**CITY OF ISANTI
PLANNING COMMISSION MEETING
TUESDAY, June 21, 2022
Immediately following 7:00pm City Council Meeting
CITY HALL**

SUBJECT: Site Plan Review for an Industrial building located at 605 E Dual Blvd NE for RK Unlimited Welding

Date: June 3, 2022
To: Stephanie Hillesheim, Community Development Director
From: Jason W Cook, P.E.
City Engineer
Subject: RK Unlimited Welding – Site Plan Review
City of Isanti, MN
Project No.: 0R1.126218

Date: June 3, 2022
To: Stephanie Hillesheim, Community Development Director
From: Jason W Cook, P.E.
City Engineer
Subject: Gopher State Storage – Site Plan Review
City of Isanti, MN
Project No.: 0R1.126218

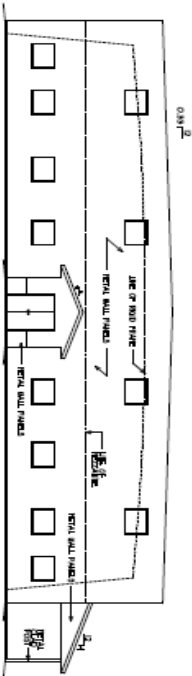
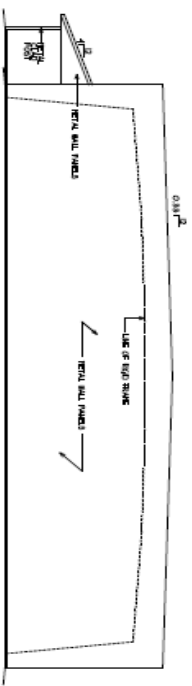
Exterior building materials mostly include prefinished metal panels for the roofing and siding of the building. According to architectural plans, there is no proposed wainscoting to complement the metal panels for the exterior of the building. The wainscoting should be placed on the two sides that are facing the roadways, on the south and east of the building. Wainscoting is required to be one-third of the sidewall height and consist of face brick, natural stone, or decorative concrete block. Colors for the building materials were not specified on architectural plans but will need to complement surrounding structures in the Industrial District.

The exterior elevations on the south of the building show two garage doors that may be used for loading. The building orientation will be facing south toward the road and the east of the site will be facing East Dual Blvd. There are existing trees on the southwest of the site that will shield the building and loading area

3. Wainscoting shall be placed on the east and south sides of the building and shall follow Section 8, Subd. 13 of the City's Zoning Ordinances for exterior building materials

CONCRETE VALLEY GUTTER		BMI DETAIL PLATE NO: 7-100	APPROVAL:	DATE:	DETAIL LOG	
			STDS COMM.	SPRING, 2006	REVISIONS:	DATE:
PATH: Y:\7-100		REMARKS:				
ORIG. PROJ:						
PROJ. #:	ENG/TECH:

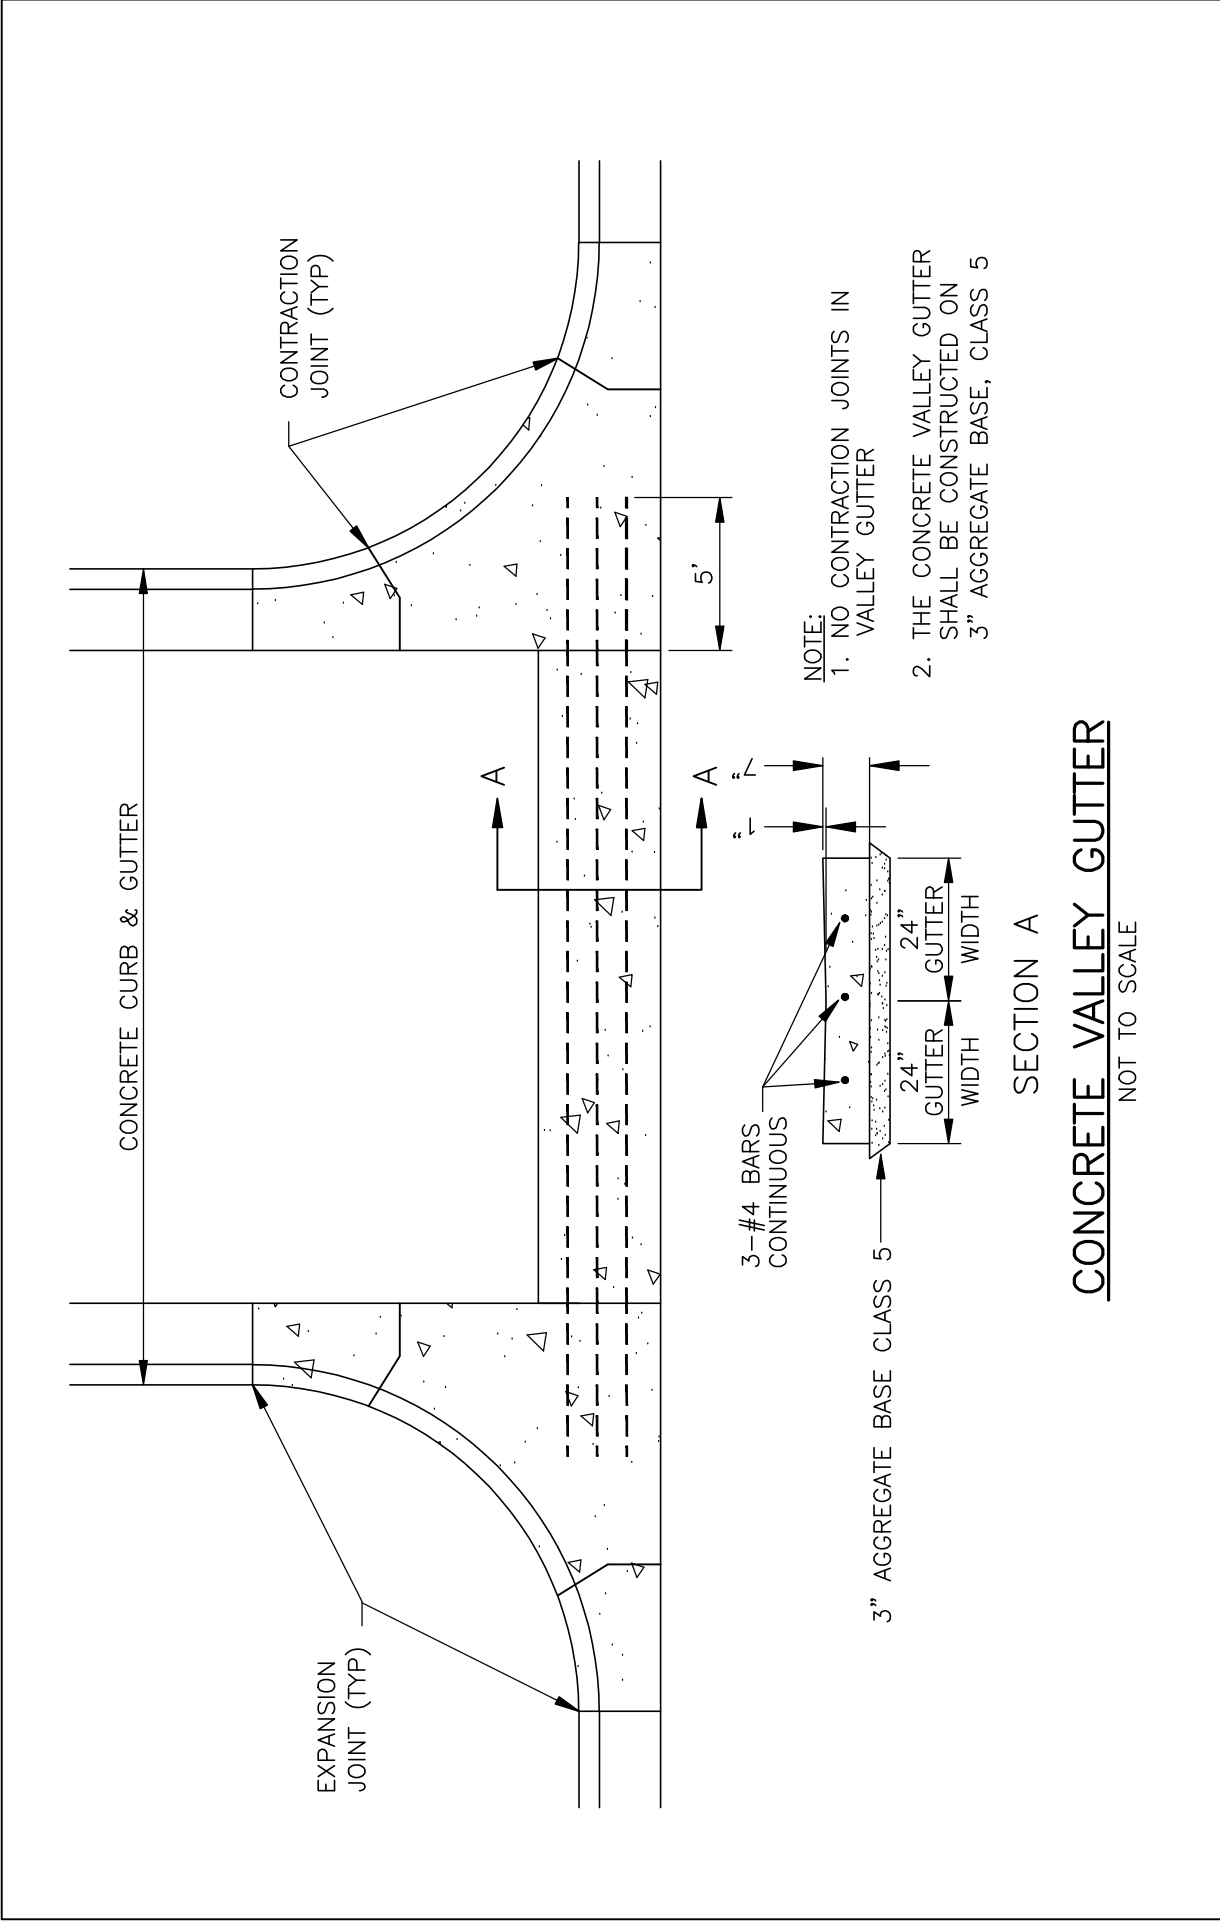
- b. Construct valley gutter on East Dual Boulevard – (see attached detail)
2. Sheet C 3 of 6 – Grading & Drainage Plan:
 - a. The storm water ponds will need to have an impervious liner to ensure no infiltration occurs and the dead storage is maintained.

Utility Plan
Plan & Profile

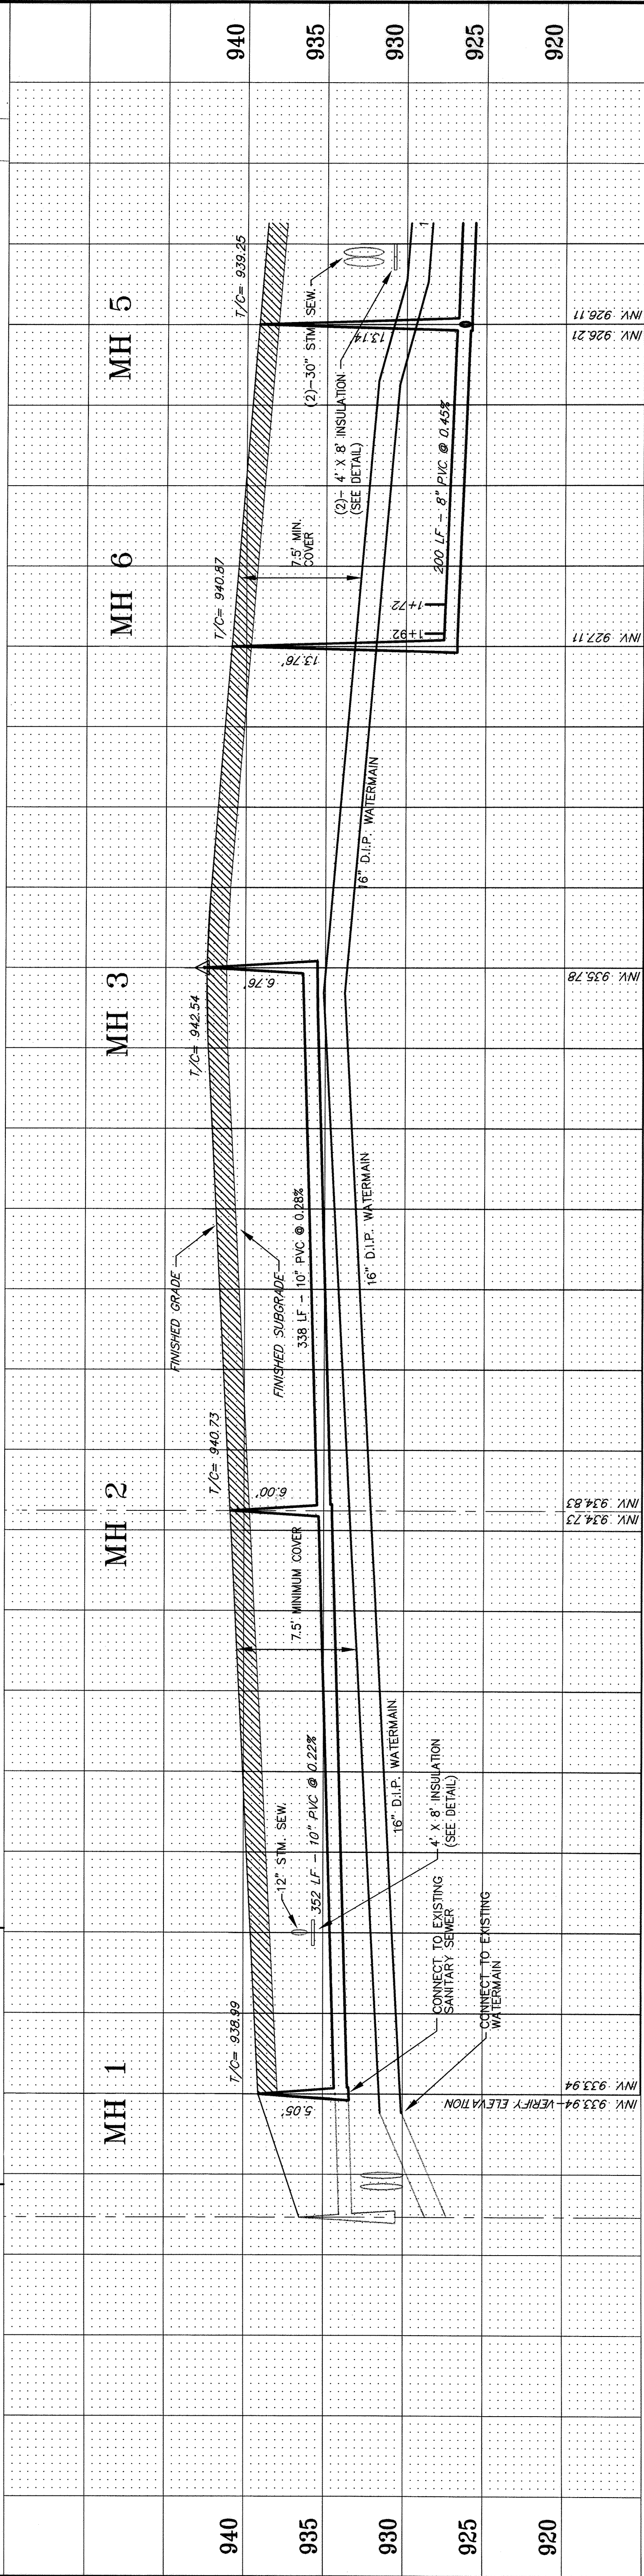
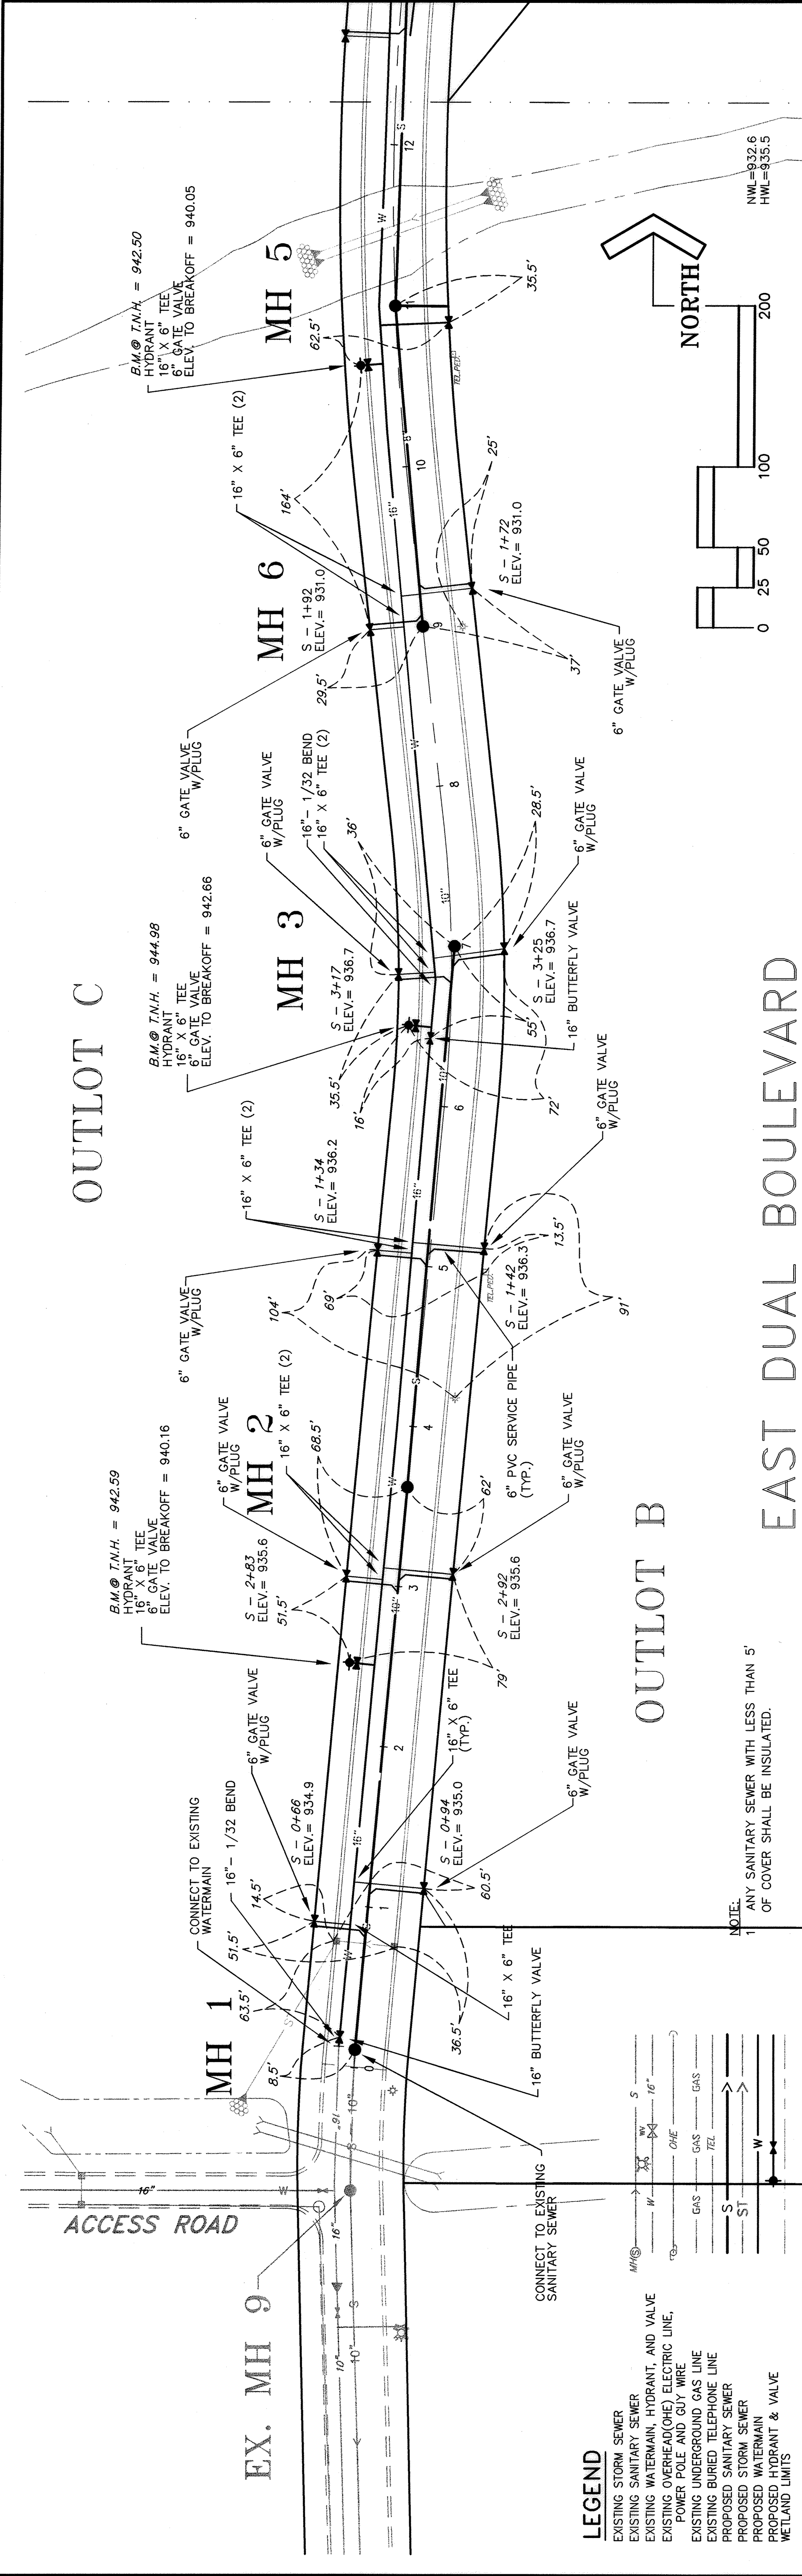
- a. Connect to existing sanitary sewer stub to avoid cutting into street – (see attached record drawing)
6. Sheet A010 – Site Plan & Details
 - a. Large “future parking and drive” area appears to be over existing ditch and drainage & utility easement. Confirm this is not needed for the future building expansion, or describe plan to maintain ditch flow with future parking expansion.
